LOST CREEK I MASTER DEVELOPMENT PLAN

Re: Lost Creek I (Amendment)

MDP # 822-A

The City Staff Development Review Committee has reviewed Lost Creek I (Amendment) Master Development Plan M.D.P. # 822-A. Please find enclosed a signed copy for your files. Your plan was accepted however please note the following:

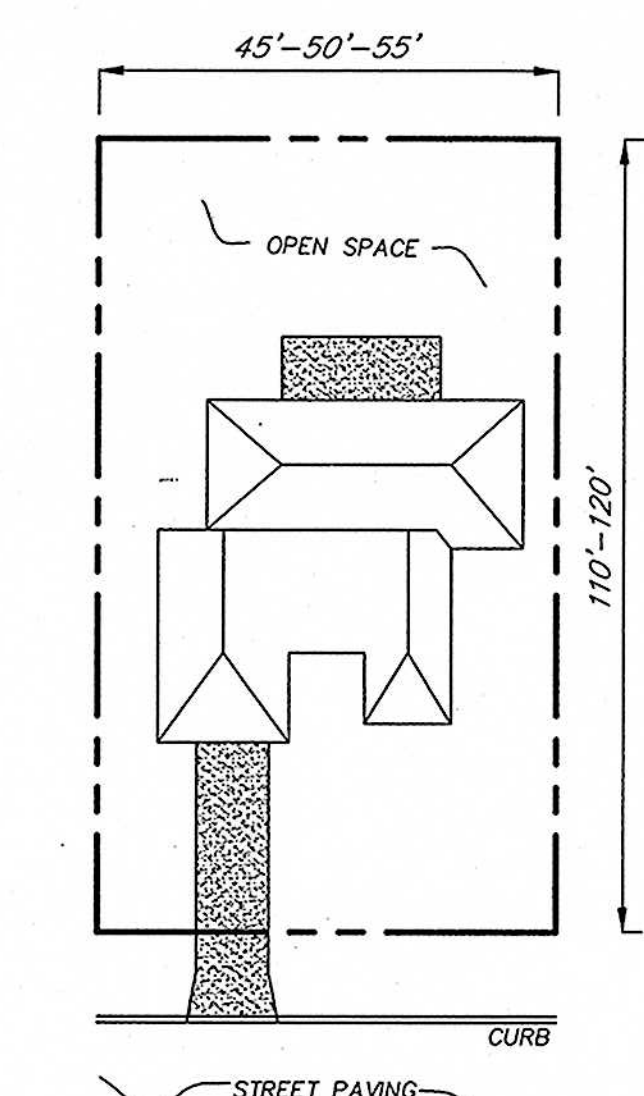
- Construction of an internal collector street system from IH 10 Frontage Road to Old Fredericksburg Road approximately 800-feet in length. Collector street design parameters consist of 70-feet of ROW and 44-feet of pavement (Table 506-3). The proposed collector street shall have no houses fronting (UDC 35-515, (c), (4)).

- Construction of an internal collector street system from Old Fredericksburg Road into the Lost Creek subdivision approximately 250-feet in length. Collector street design parameters consist of 70-feet of ROW and 44-feet of pavement (Table 506-3). The proposed collector street shall have no houses fronting (UDC 35-515, (c), (4)).

- Construct a northbound right-turn deceleration lane with a storage lane and bay taper as it relates to the submitted TIA traffic counts, (Uniform Development Code (UDC) - 35-502 (a)(7), subsection C, at the intersection of the IH-10 Westbound Frontage Road and the proposed collector.

- Construct a northbound right-turn deceleration lane with a storage lane and bay taper as it relates to the submitted TIA traffic counts, (Uniform Development Code (UDC) - 35-502 (a)(7), subsection C, at the intersection of Old Fredericksburg Road and the proposed collector/entrance to the residential subdivision.

1. Provide pavement transition from the entrance Collector Street to the respective Local Type A.
 2. It should be understood that this is a general review of a conceptual plan and that *all* technical requirements of the Unified Development Code for Streets & Drainage shall be complied with.

- Provide right-turn deceleration lanes for access to IH-10 Westbound and the collector access on Old Fredericksburg Road as outlined by the Texas Department of Transportation.

- All access shall conform to 35-506(r) of the Unified Development code providing adequate driveway throat design and provisions for common access.
 - Secondary access to the proposed residential development shall be secured prior to approval of any plat exceeding 125 single family dwelling units within this development.
